CONTEMPORARY NEW CONSTRUCTION RESIDENCE

NEW CONSTRUCTION
6405 S.RHODES Ave., Chicago IL 60637

CITY OF CHICAGO
DEPARTMENT OF BUILDINGS
Certified Corrections Program
Professionals of Record Certification Statement

Application Number: 100906535

10 INTERIOR STAIRS PLAN AND SECTION

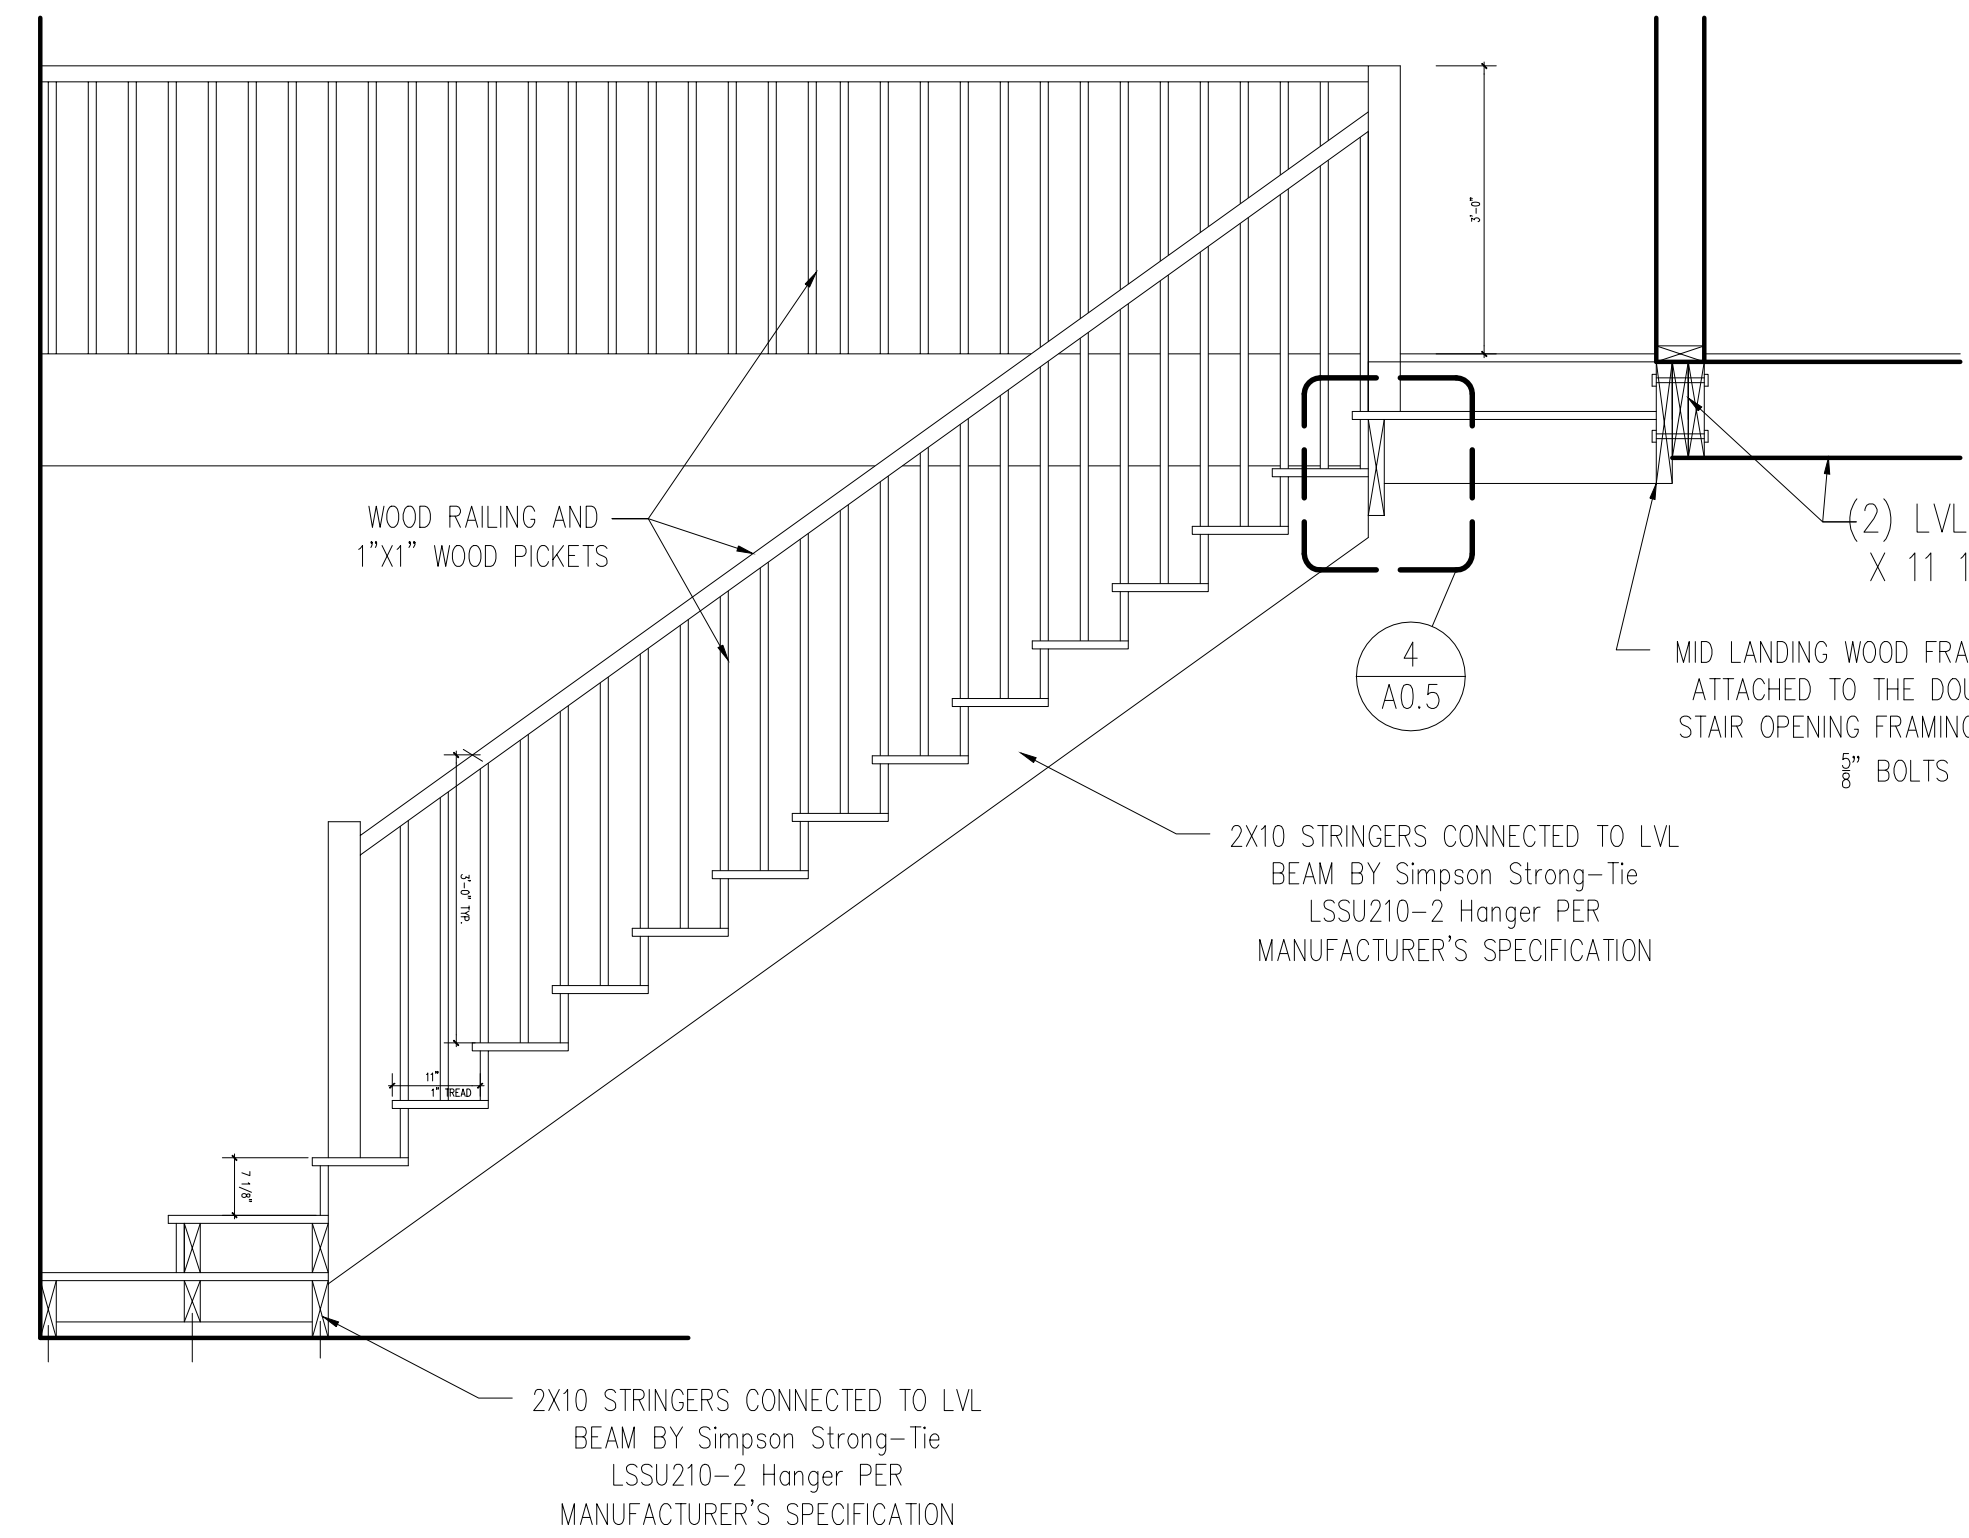
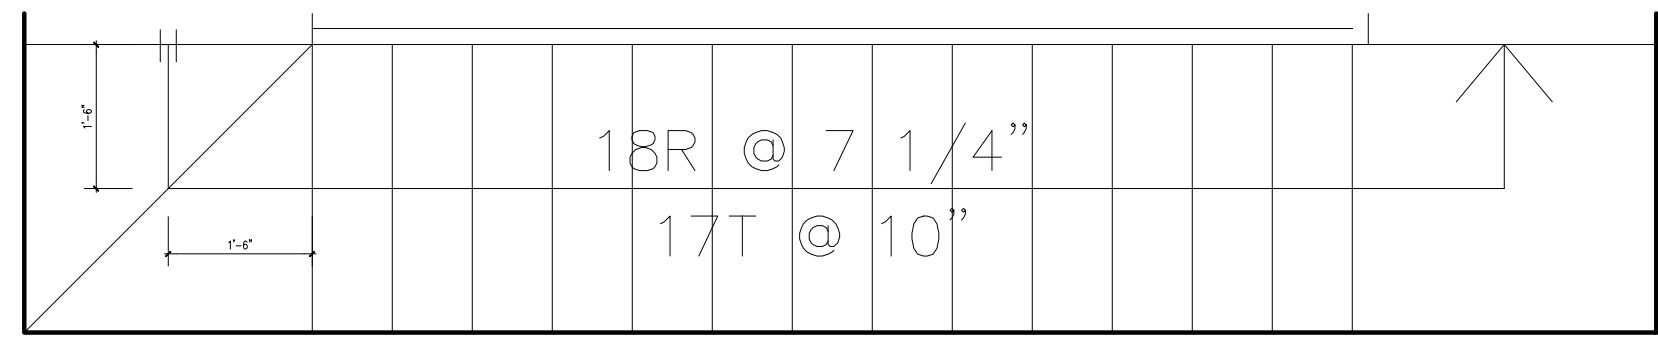
10	Complied		Arch2	1	Oscar Audifred	A0.2- FRAMING PLANS_APP#100906535.pdf	Arch	ara0000	ARA0000+ ADMINISTRATIVE ISSUE ?? WHAT IS THIS ?	3/5/2021 7:55:09 am	Landing framing and attachments are added to the detail 10/A0.2 of the interior stairs. The change is clouded and dated.	3/11/2021 3:34:33 pm
6	Not Complied		Refrigeration	1	Ronald Gardner	M0.1- MECH PLANS_APP#100906535.pdf	REFRIGERATION	RA2342	RA2342 - Examiner comments (30-400) ADD THE GAS PIPING NOTE TO THE PLAN. NATURAL GAS DISTRIBUTION PIPING SHALL BE SCHEDULE 40 BLACK PIPE WITH 150# MALLEABLE IRON FITTINGS.	2/23/2021 7:45:25 am	The required note is added in sheet M0.1 and clouded and dated.	3/11/2021 2:48:26 pm
7	Not Complied		Refrigeration	1	Ronald Gardner	M0.1- MECH PLANS_APP#100906535.pdf	REFRIGERATION	RI1700	RI1700 - Bubble, Date, and Initial all changes to plans.	2/23/2021 7:45:26 am	All changes in drawings are clouded and dated.	3/11/2021 2:37:59 pm

3 BASEMENT ELECTRICAL PLAN
SC 1/4" = 1'-0"

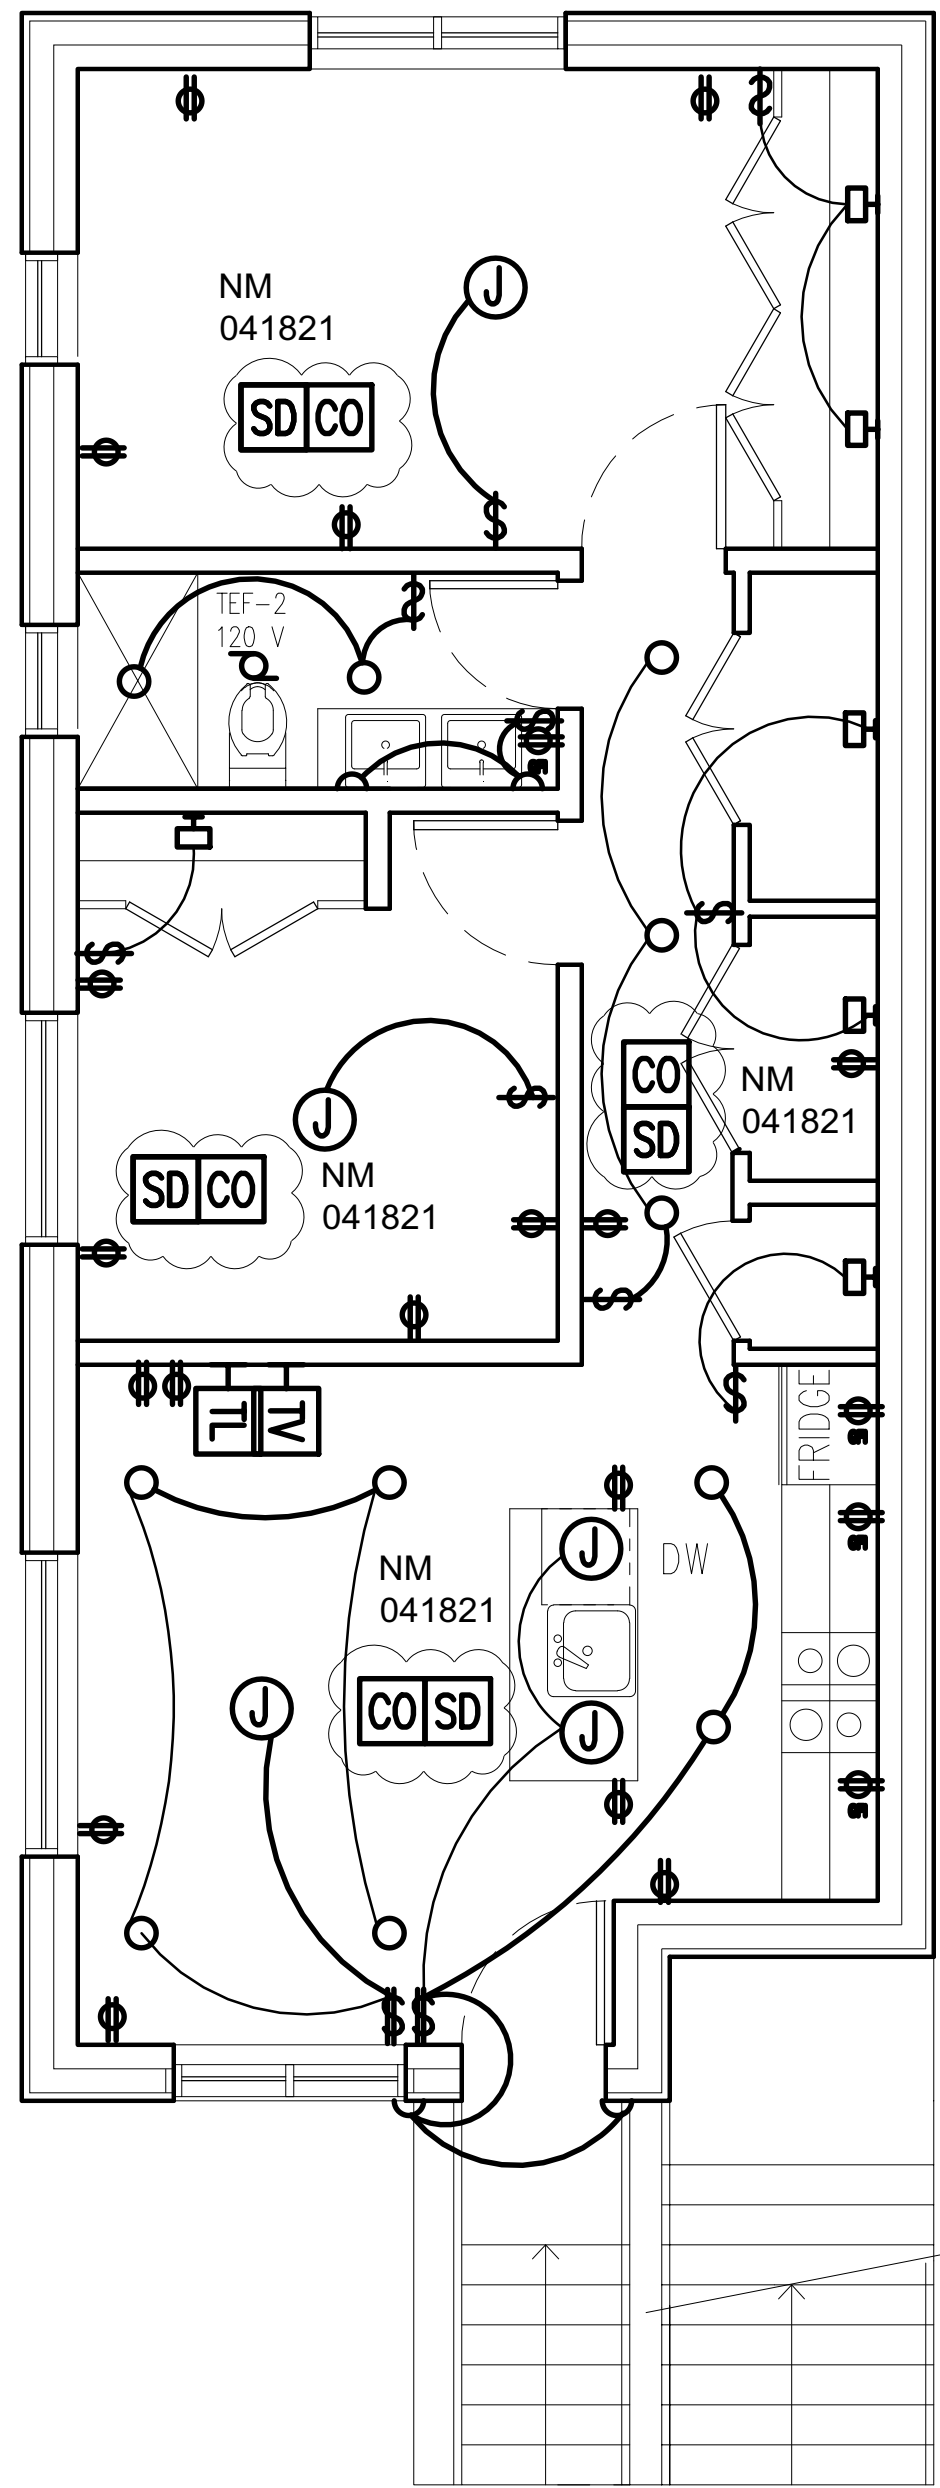
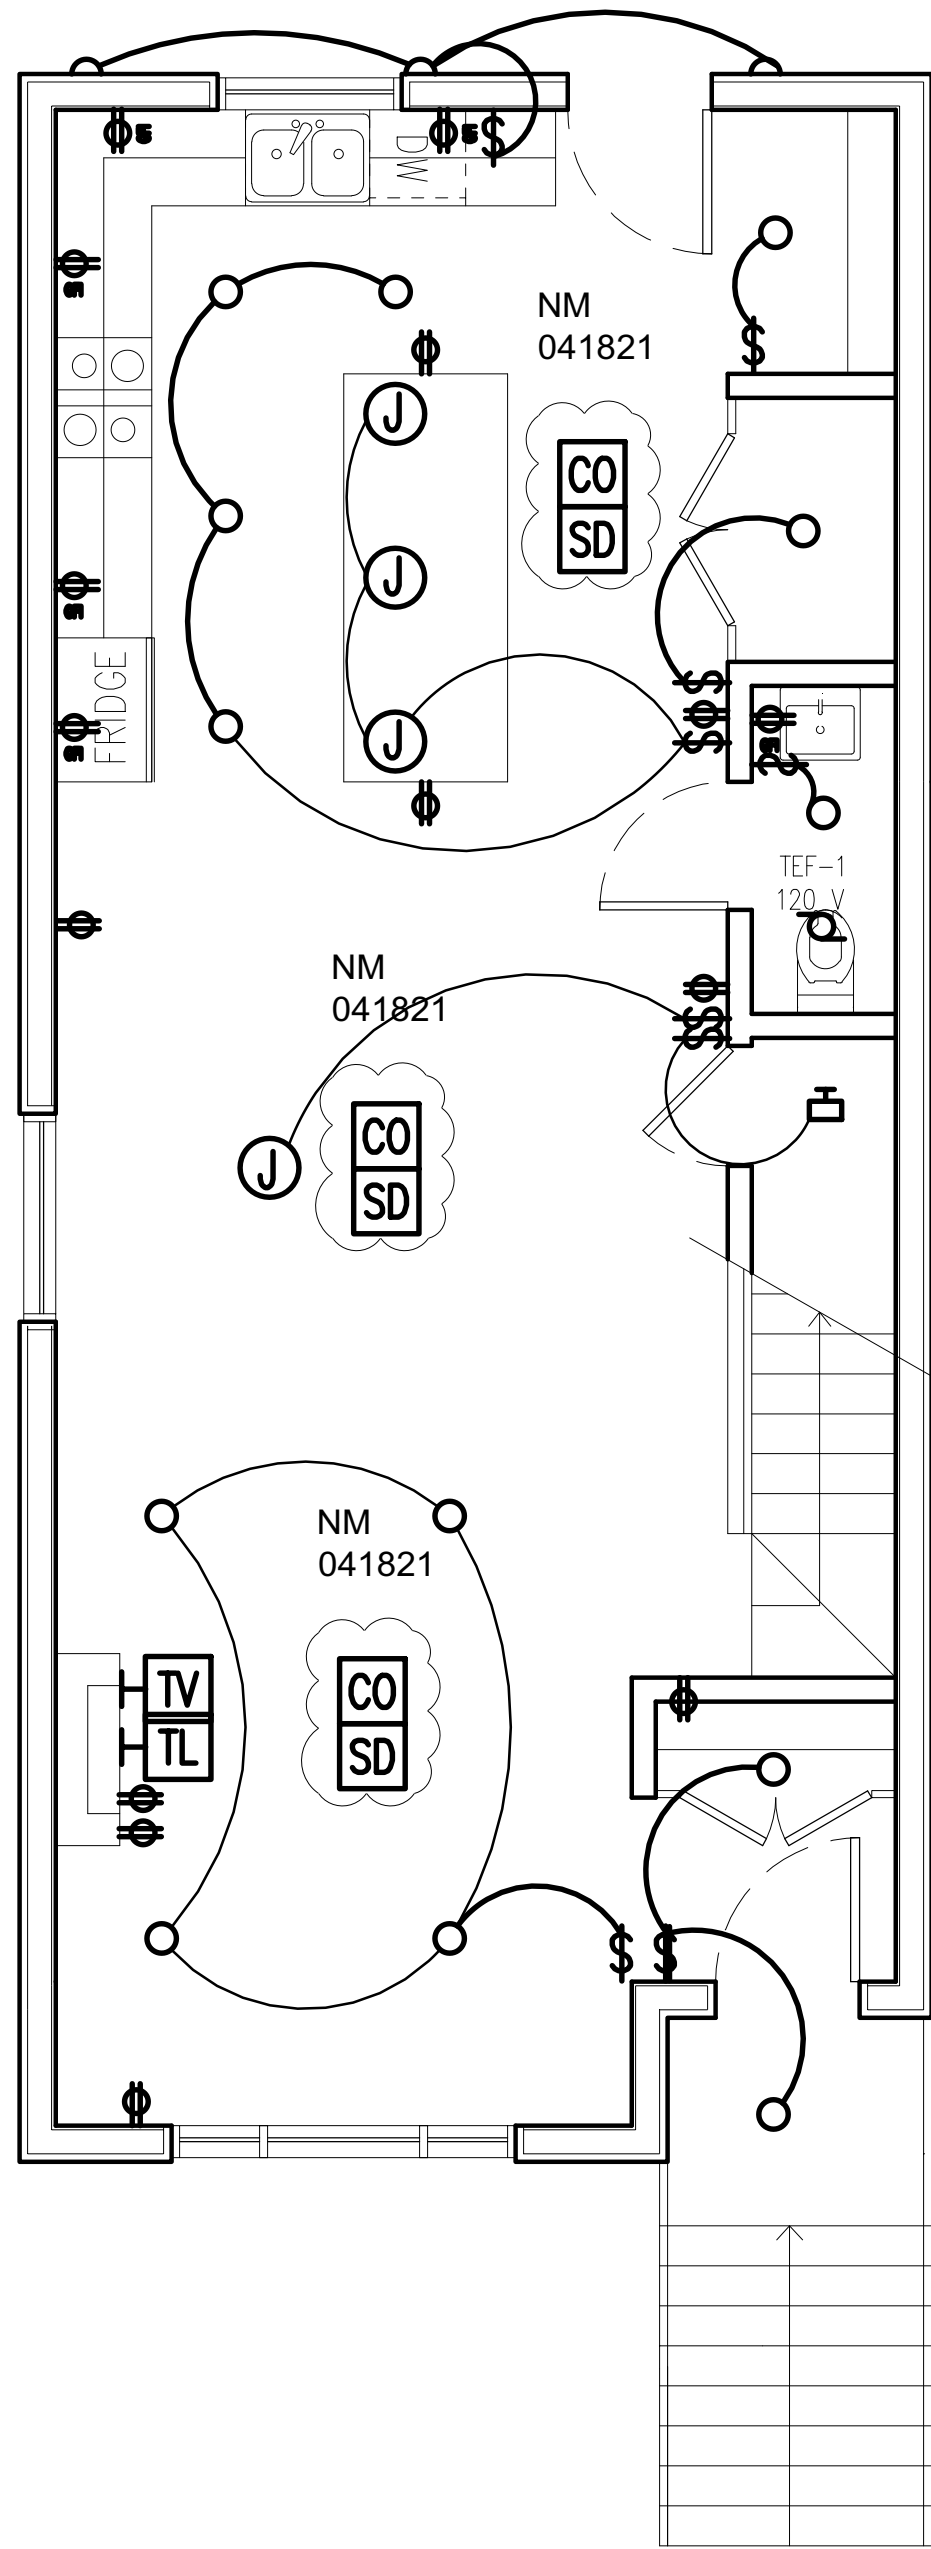
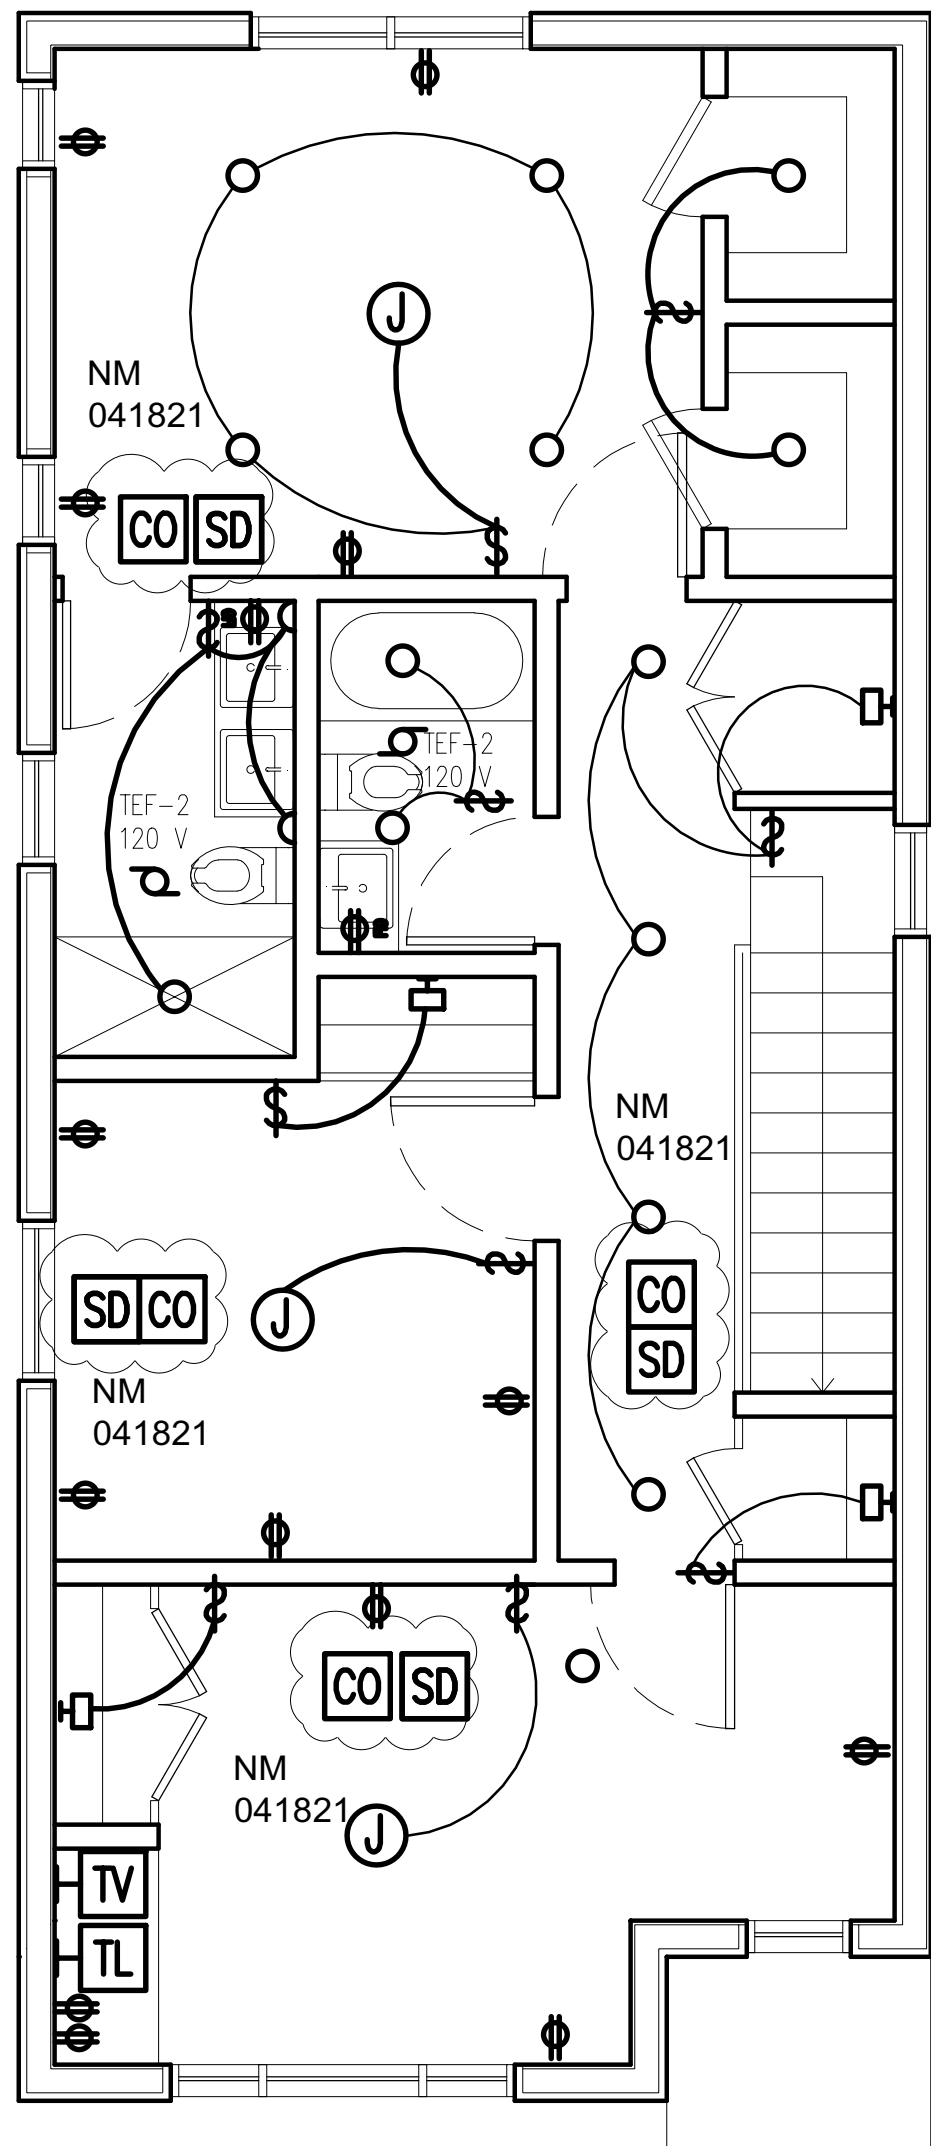
21	Complied		Arch2	2	Oscar Audifred	E0.1- ELEC PLANS_APP#100906535.pdf	Arch	ara0000	ARA0000+ ADMINISTRATIVE ISSUE PLEASE SHOW ALL REQ. CO ALARMS AT ALL REQ. LEVELS, LOCATIONS.	4/16/2021 11:12:56 am	All required CO alarms are added to the electrical sheet E0.1 on all levels and clouded and dated.	4/25/2021 4:50:39 pm
18	Complied		Arch2	2	Oscar Audifred	A0.1- ARCH PLANS_APP#100906535.pdf	Arch	ara0000	ARA0000+ ADMINISTRATIVE ISSUE - STILL NOT SHOWING SUPPORTING STRUCTURE FOR PORCH AND/OR STAIRS. YOU ARE NOT PROVIDING ALL REQ. FRAMING INFO FOR NEW FRONT STAIRS. HERE OR ON FRAMING PLANS - ALSO FOR THE FRONT STAIR ROOF - STILL NOT SHOWING ALL REQ. GUARDRAIL (AT BASMENT STAIRS)	4/16/2021 11:08:32 am	There is no porch in the back. It is a deck and does not have a roof. The back deck structure is shown in sheet A0.2 including columns, edge beams, stair stringers and floor joists and details referenced in sheet A0.5. Framing for front stair and the stair roof are added to framing plans in sheet A0.2, guardrails for basement stairs are added in elevation 3, 1A0.2 and clouded and dated.	4/25/2021 4:50:39 pm

5	Not Complied		Electrical	1	ralph palombizio	E0.1- ELEC PLANS_APP#100906535.pdf	E	NOTE0001	NOTE0001 OUTLETS ARE REQUIRED ON KITCHEN ISLANDS	2/23/2021 7:28:24 am	Outlets are added on the kitchen island sides in sheet E0.1 and clouded and dated.	3/11/2021 2:37:59 pm
